IFB No. 20-20 Washington Elementary School Chimney Stack Removal Project  
DATE: February 21, 2020  
RE: **ADDENDUM NO. 1**

WASHINGTON ELEMENTARY SCHOOL  
CHIMNEY REMOVAL  
ROCKFORD PUBLIC SCHOOLS 205  
ROCKFORD, ILLINOIS

Changes to Bidding Documents Dated January 28, 2020

PROJECT NO.: 29138

DATE: 01-28-2020
PROJECT NUMBER: 29138
SHEET NUMBER: M1.1

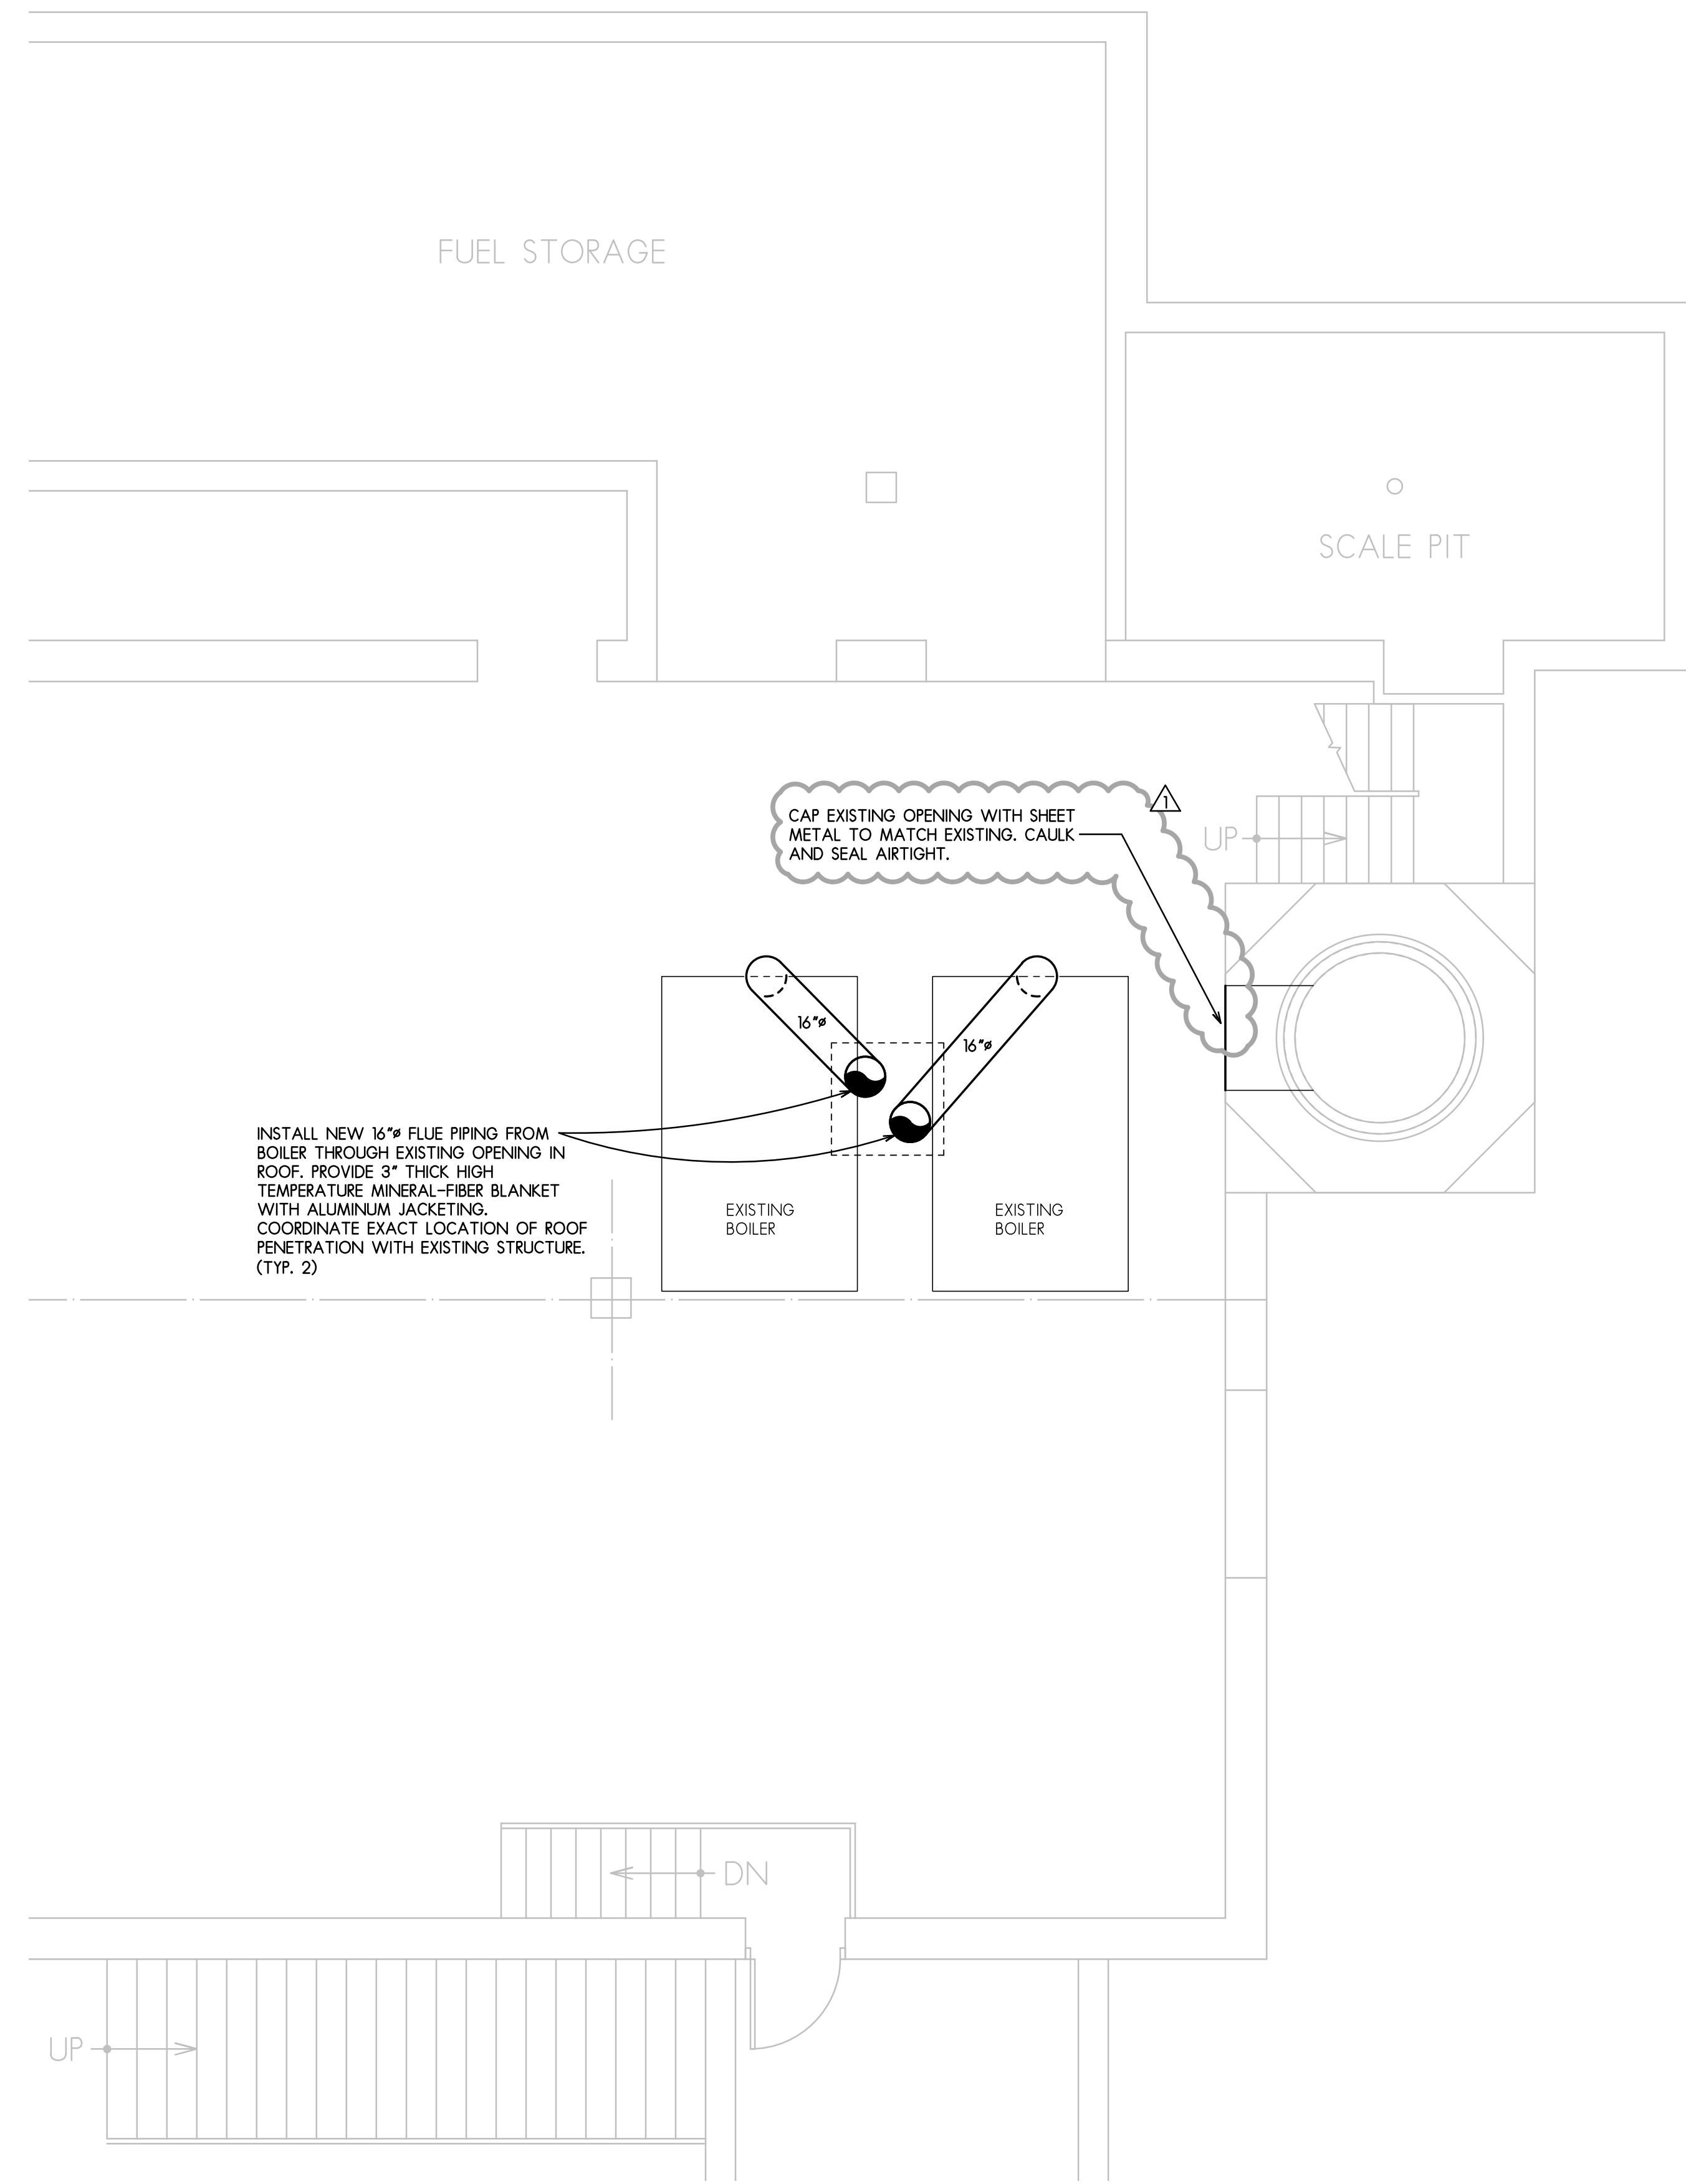
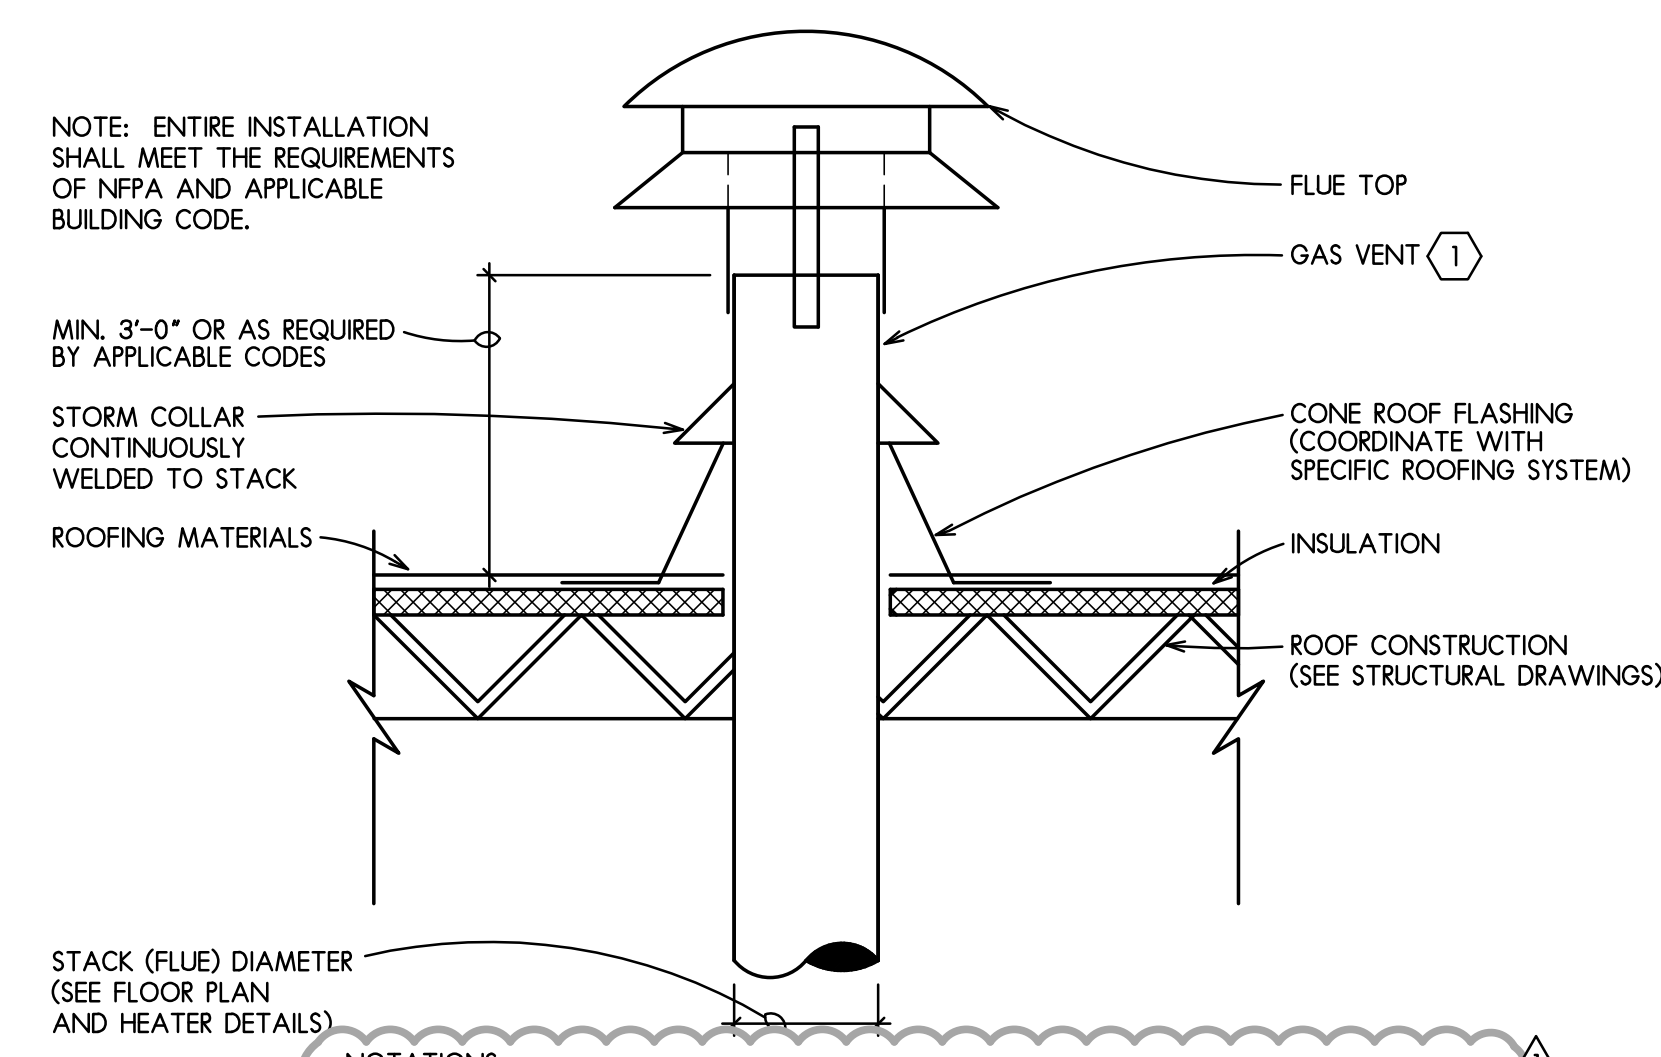
- I. ADDITIONS OR CHANGES TO THE DRAWINGS
  - A. See attached Revised Drawing M1.1.
